VARIANCE FOR A BALCONY ADDITION TO THE FRONT OF A SINGLE-FAMILY DWELLING

Tax account 173090050525
359 BERKSHIRE DRIVE, RIVA MD 21140
LOT 2 OF STAFFORD ESTATES SUBDIVISION
Critical Area Designation LDA
Property is water front with to tidal waters of the united states

CONFIRMATION OF PRE-FILE (2024-00011-P)

Steep slopes Site plan

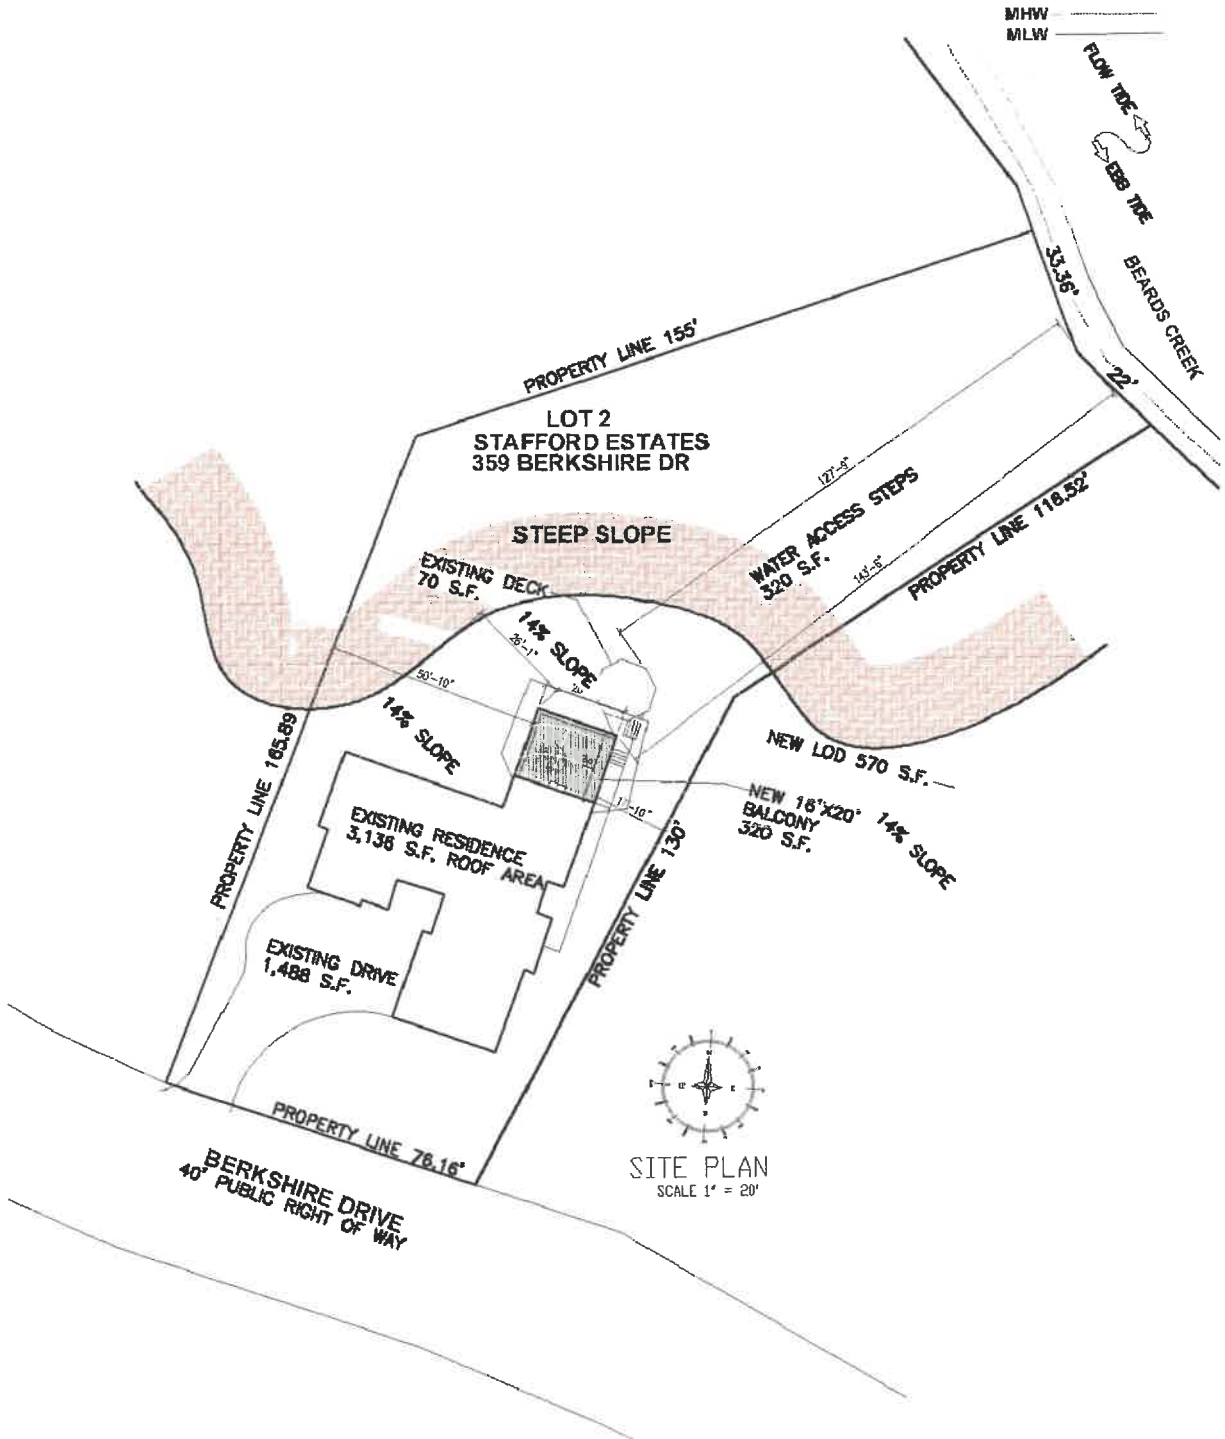
As per COMAR and Article 18-13-104 this site has Critical Area buffer located onsite as the Critical Area buffer includes contiguous slopes greater than 15% and includes all land within 50 feet from the slope. This site is mapped Critical Area buffer and includes contiguous slopes greater than 15%. Please show the location of the Critical Area buffer onsite. Disturbance is not permitted to the Critical Area buffer without a variance. Please contact our Zoning Division at (410) 222-7437 to discuss the variance application process.

A 25 foot undisturbed buffer must be maintained from the top of 25% or greater slopes within a sensitive area.

(1) If there are contiguous slopes of 15% or greater, the buffer shall be expanded by the greater of four feet for every 1% of slope or to the top of the slope and shall include all land within 50 feet of the top of the slopes. A VARIANCE IS REQUESTED TO REDUCE THE REQUIRED 50' STEEP SLOPE EXPANDED BUFFER TO 26', A 24' REDUCTION TO THE 50' EXPANDED BUFFER IS REQUESTED.
